VILLAGE OF VILLA PARK
Village Hall, Board Chambers
20 South Ardmore Avenue
Villa Park, IL 60181

Zoning Board Of Appeals (ZBA)

September 10, 2025

TO: Zoning Board of Appeals
FROM: Community & Economic Development Department
DATE: September 10, 2025
RE: **Petition ZBA-25-01 | 580 E. Harrison Avenue | Variation**

PLAT OF SURVEY
 Prepared By
MARCHESE AND SONS, Inc.
 10 Madison Drive
 Roseville, Illinois 60172
 Phone : (630) 684-5800
 FAX : (630) 684-6699

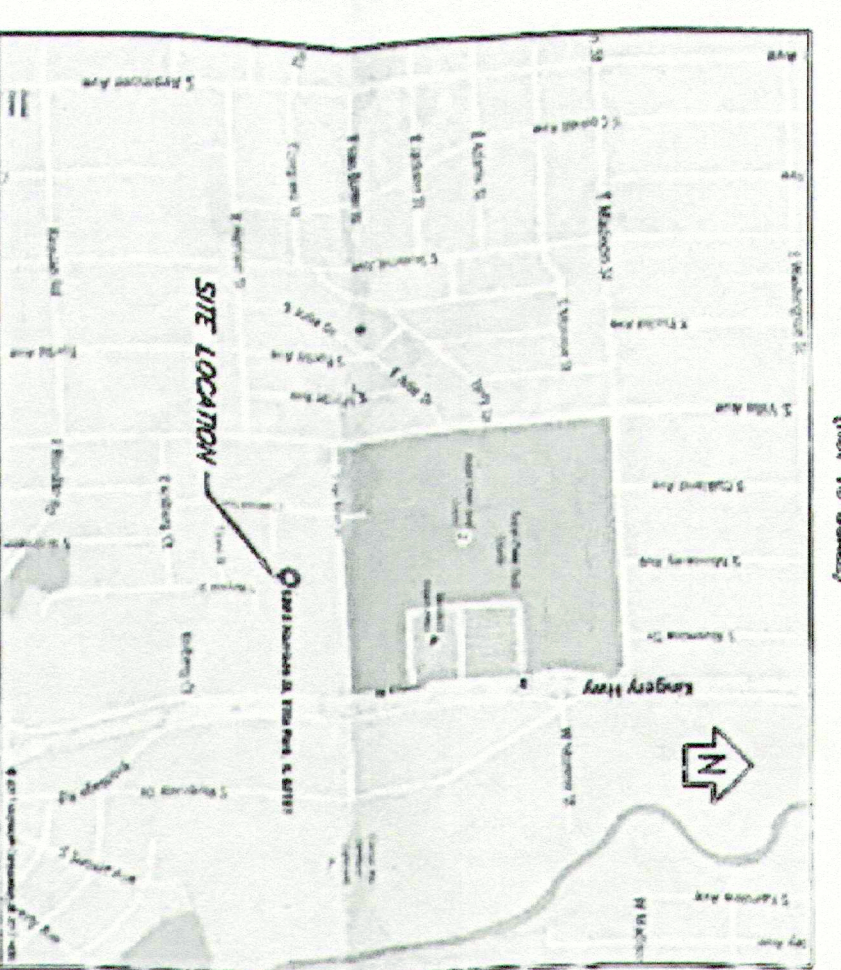
This Variation request would permit the garage to be constructed closer to the street than the house. This lot is unique because the lot line with the smallest dimension, considered the front, faces an unimproved right-of-way. The Village has installed water main within this right-of-way and would be unlikely to improve the right-of-way in the future. The layout of the home on the property would not permit another accessible location for the garage to be installed.

- a. The home faces an unimproved right of way. It is unlikely that the right-of-way would ever be improved and the road continued because there are water lines in this space.

FIRST FLOOR PLAN

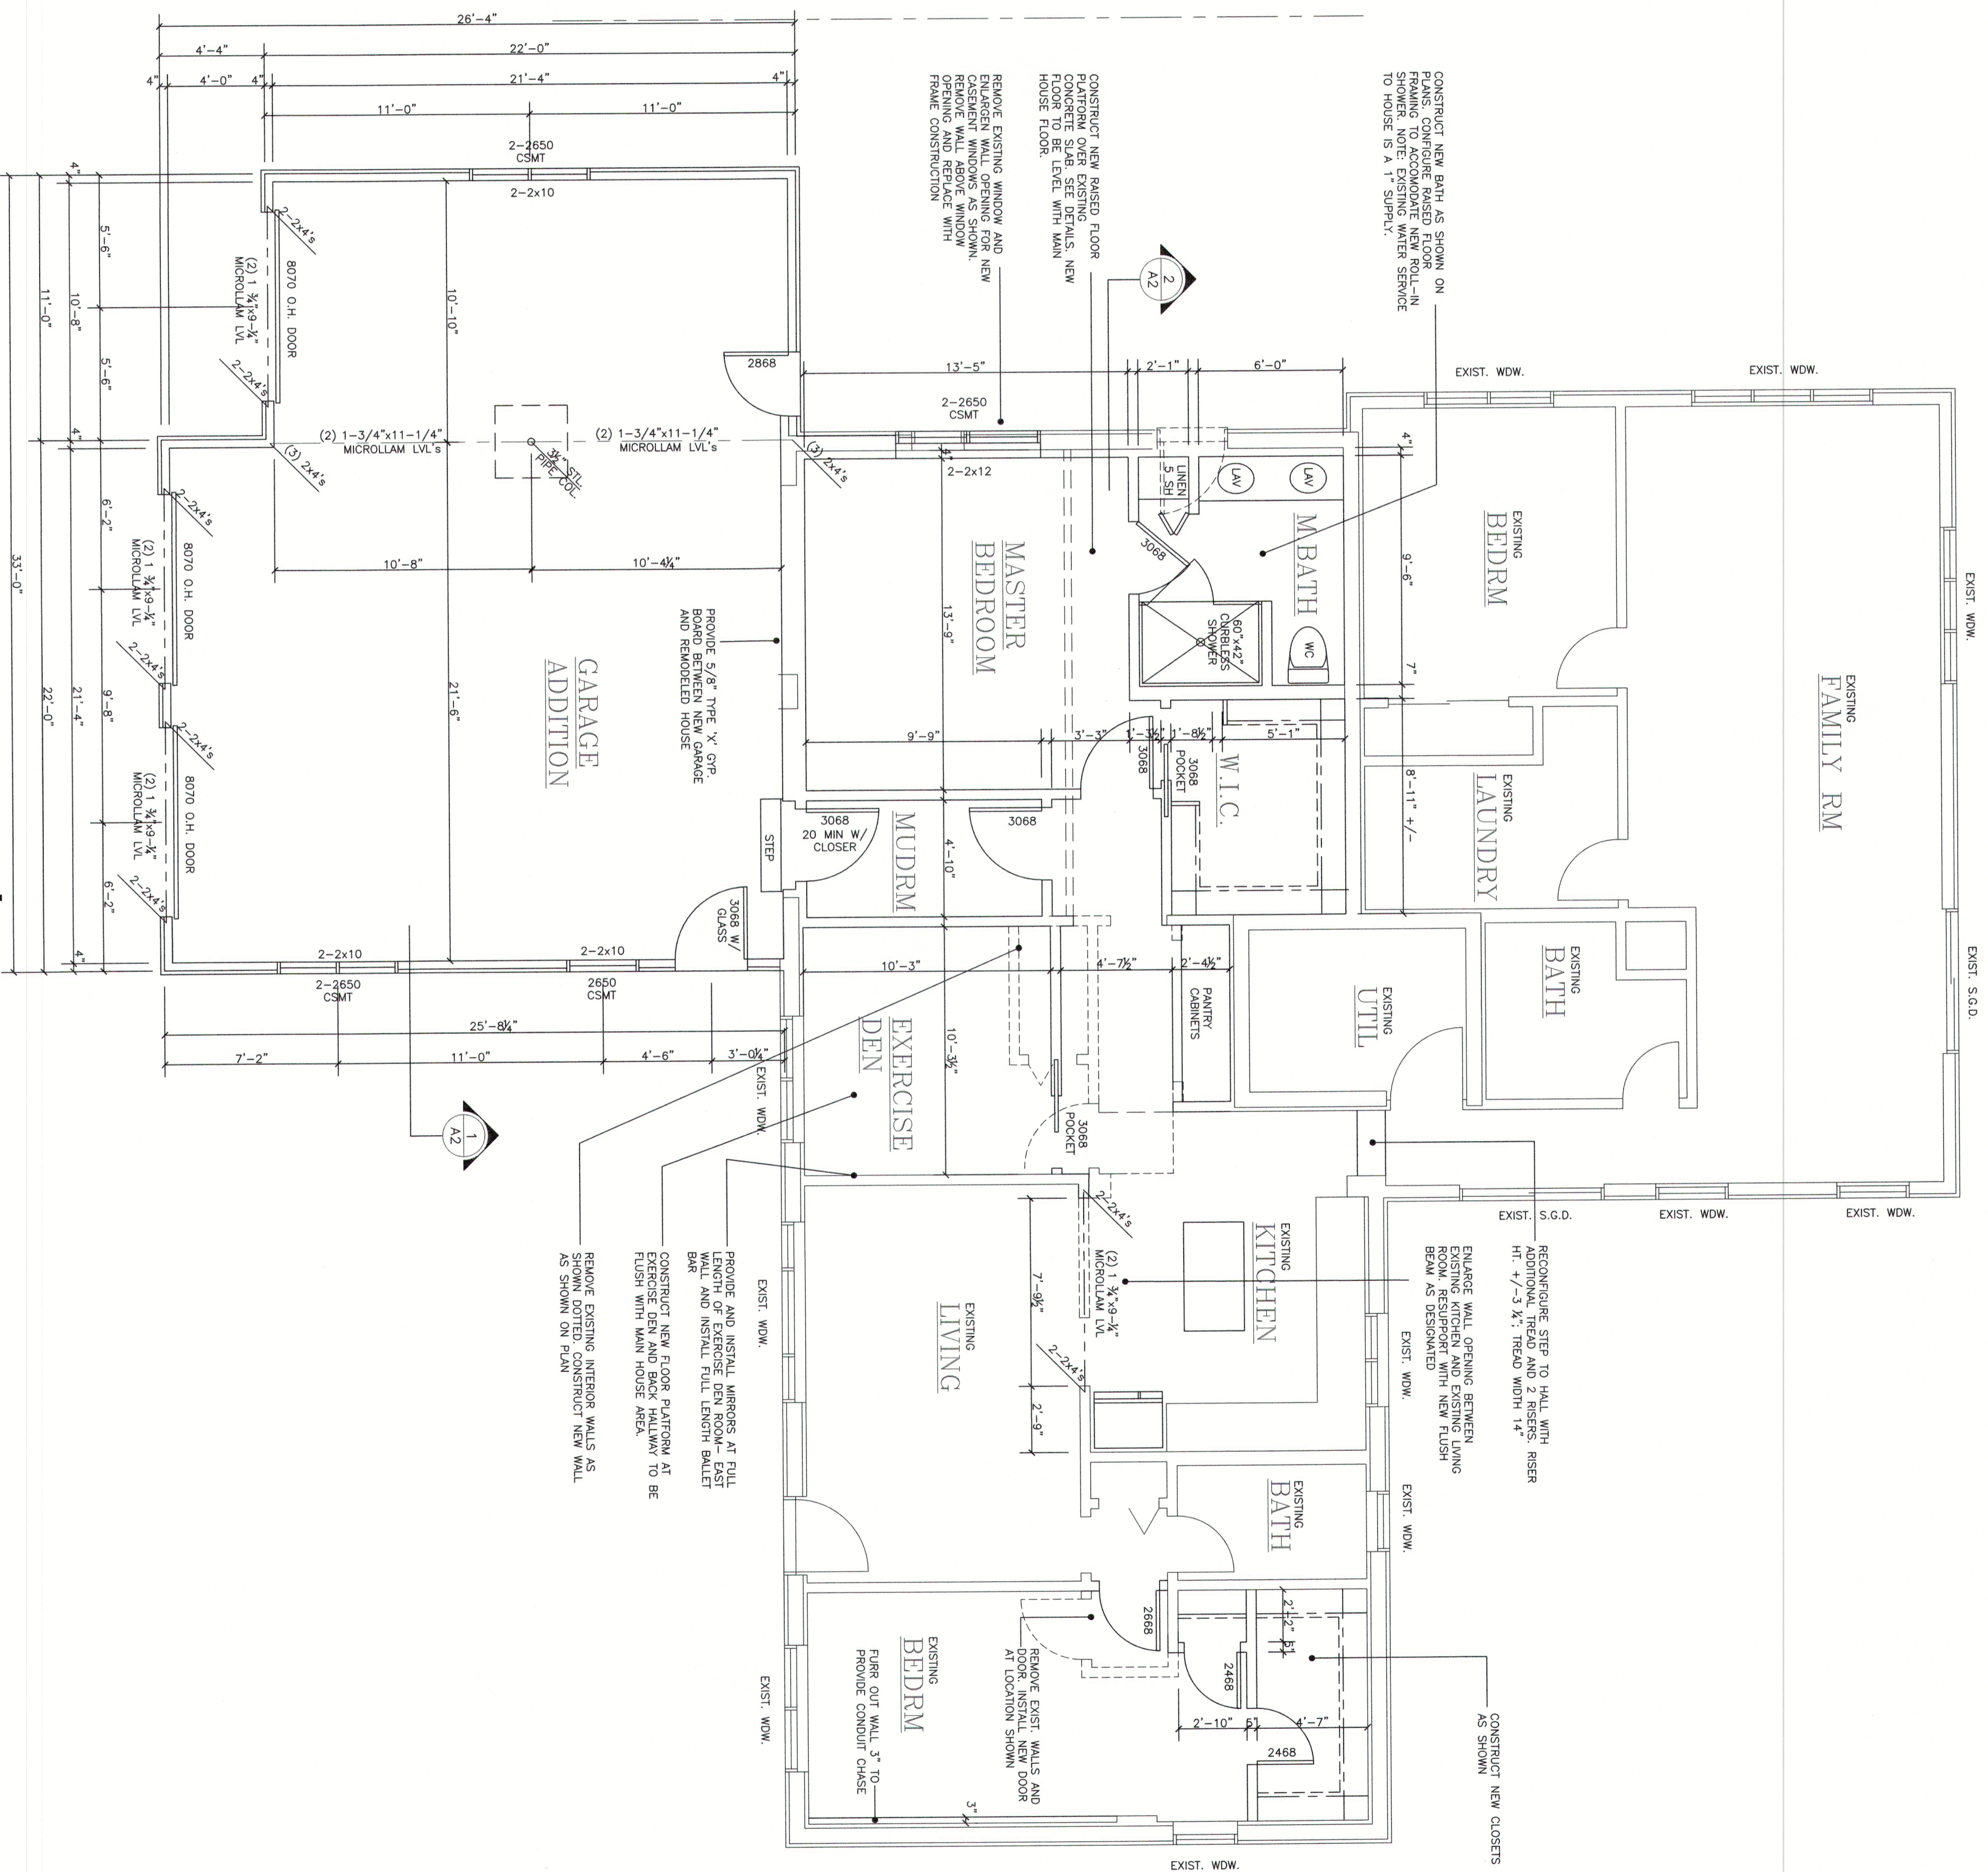
- b. The proposed garage would have an area of 795.6 sq feet. The size of the garage may not exceed 75% of the area of the primary structure, which for this lot, would be 1,721.8 sq feet.

- c. The proposed garage would have a height of 14.0 feet to match the existing roof line. The maximum height permitted is 28.0 feet.
 - d. The proposed garage would have an interior side setback of 6.2 feet and a front setback of 76.4 feet.

- e. The proposed garage is in compliance with all bulk regulations, with the exception of Section 2.5.2 Attached Garage Design (D).
 - f. With the orientation of the house and current garage location, there is no alternate location where a new garage could be accessible and comply with current regulations.
